Portland
energy recovery
facility

Environmental statement
Second addendum

January 2022

01 Elevation 01 (north-eastern)
1:250 @ A1 / 1:500 @ A3

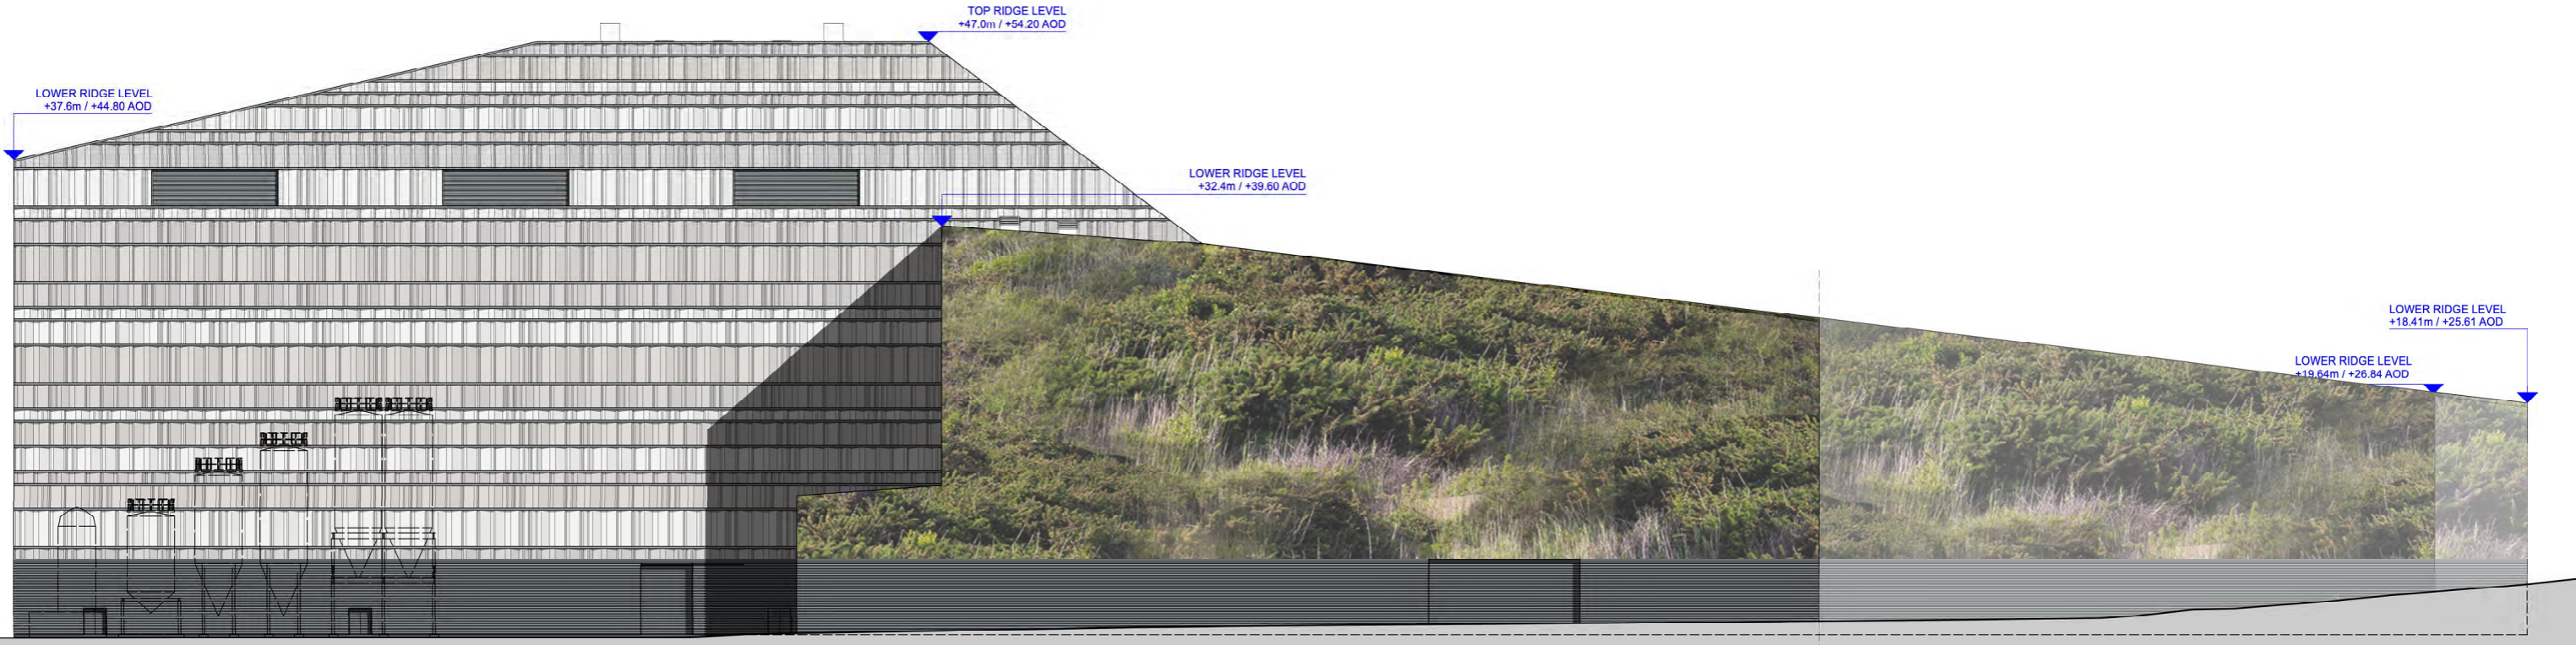
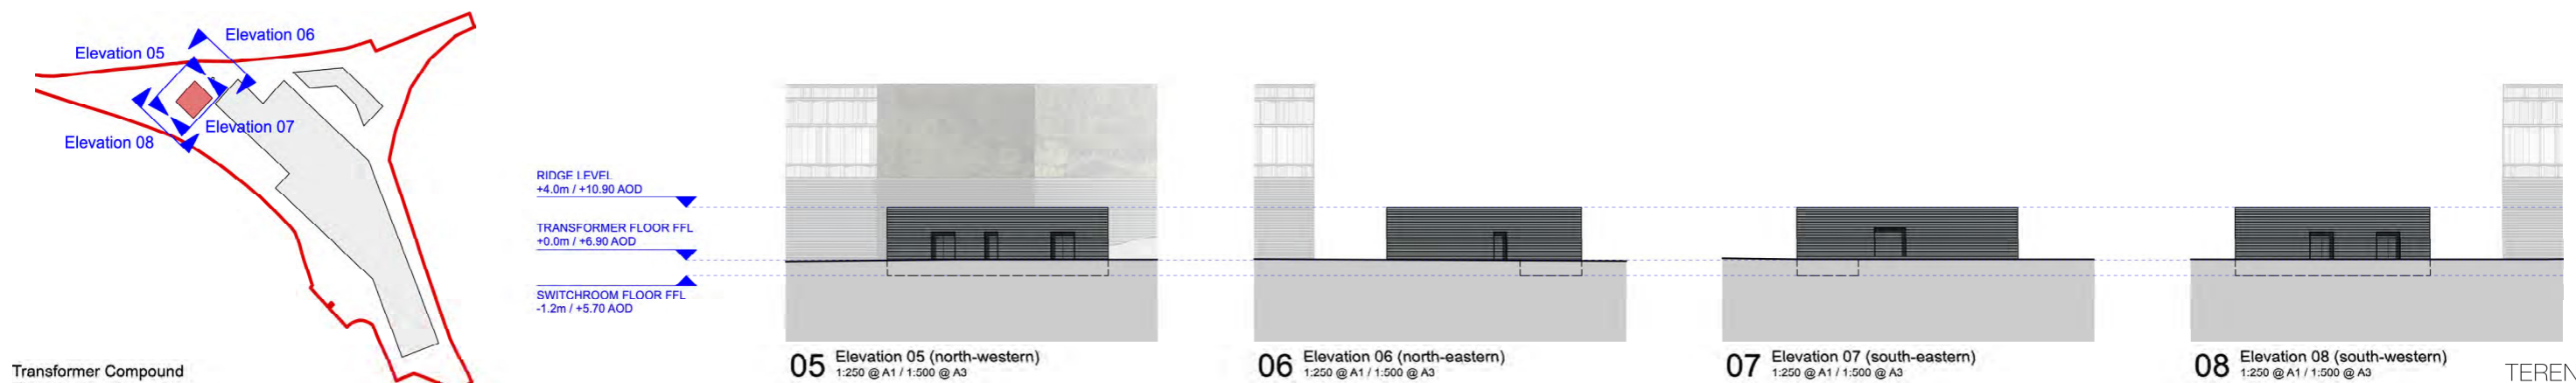
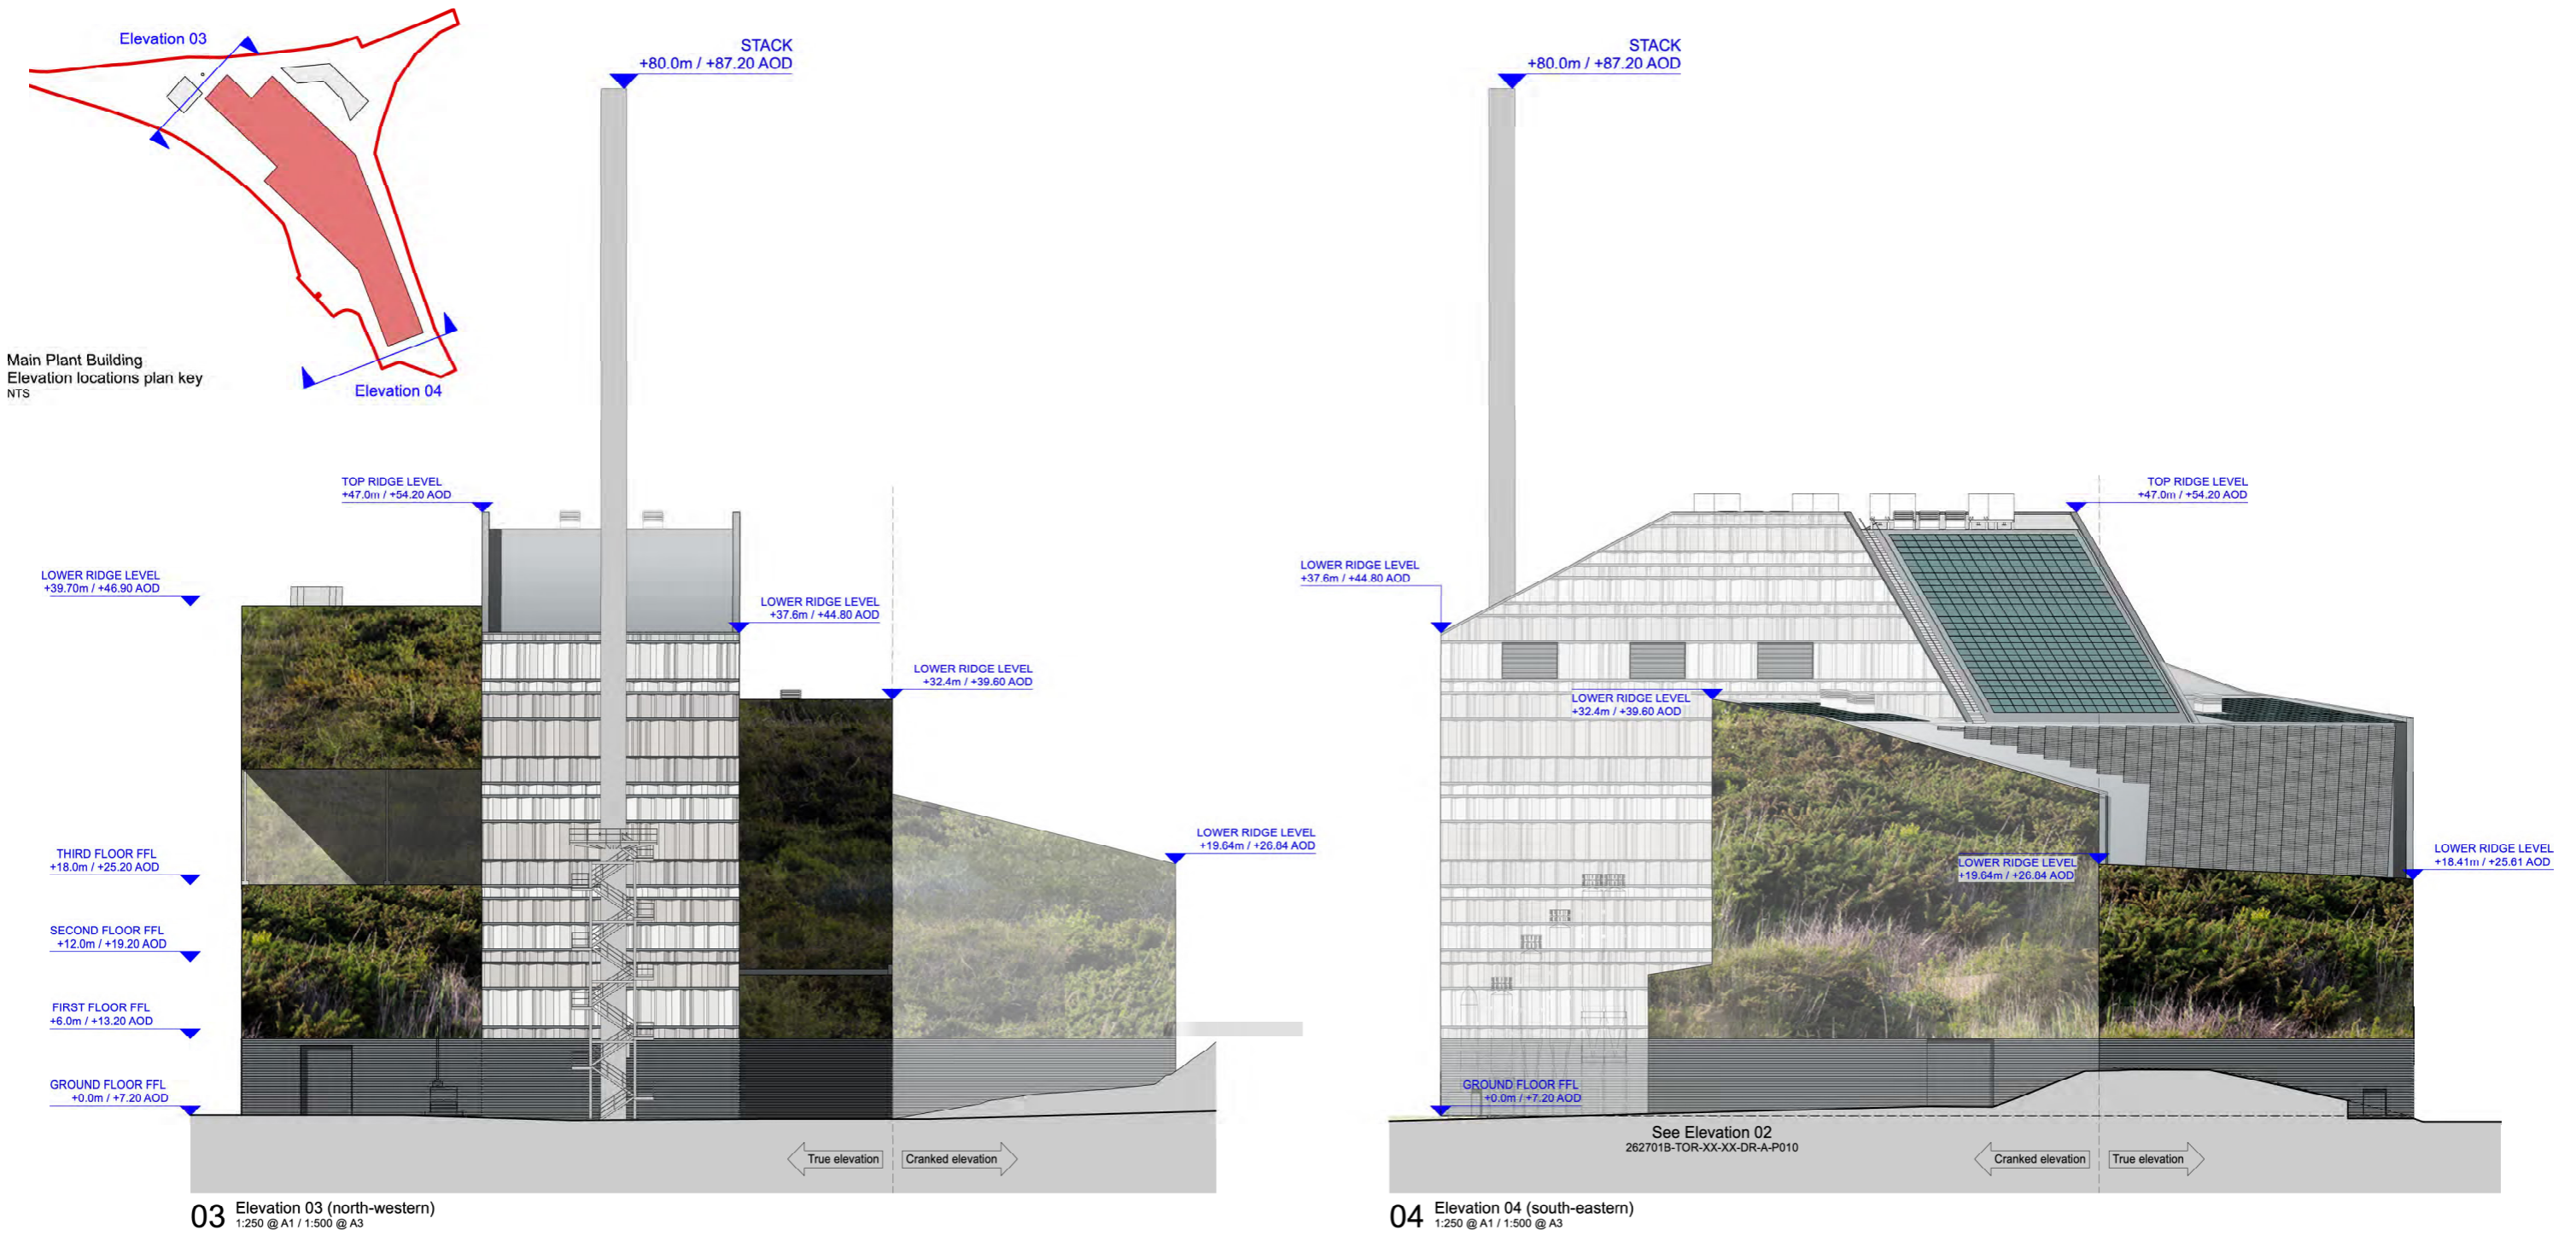
- NTS.17 The technical information provided on the diesel generator in the ES addendum includes an 8 m high stack. This was not previously shown on the elevations drawings in figures NTS.4a and NTS.4b of the original NTS, so revised versions of these figures have been prepared. These are included at the end of this report and replace the versions in the September 2020 NTS.

- More than or equal to 5%: there is potential for exceedances and the regulator will consider if this is acceptable on a case-by-case basis
- 3.13 The technical information provided on the diesel generator in appendix 3.1 includes an 8 m high stack. This was not previously shown on the elevations drawings in ES figures 2.5a and 2.5b, so revised versions of these figures have been prepared. These are included at the end of this report and replace the versions in the original ES.

- 6.9 As shown on the revised figures 2.5a and 2.5b at the end of this report, while the diesel generator and its 8 m high stack will be visible in views from the north and north east, it will be seen against the proposed main ERF building. The height and massing of the generator and its stack will be negligible in relation to the main ERF building and will therefore not lead to any new or different effects on the settings of heritage assets in the vicinity of the proposed development beyond those originally assessed.

- 8.2 As shown on the revised figures 2.5a and 2.5b at the end of this report, while the diesel generator and its 8 m high stack will be visible in views from the north and north east, it will be seen against the proposed main ERF building. The height and massing of the generator and its stack will be negligible in relation to the main ERF building and will therefore not lead to any new or different landscape, seascape and visual effects beyond those originally assessed.
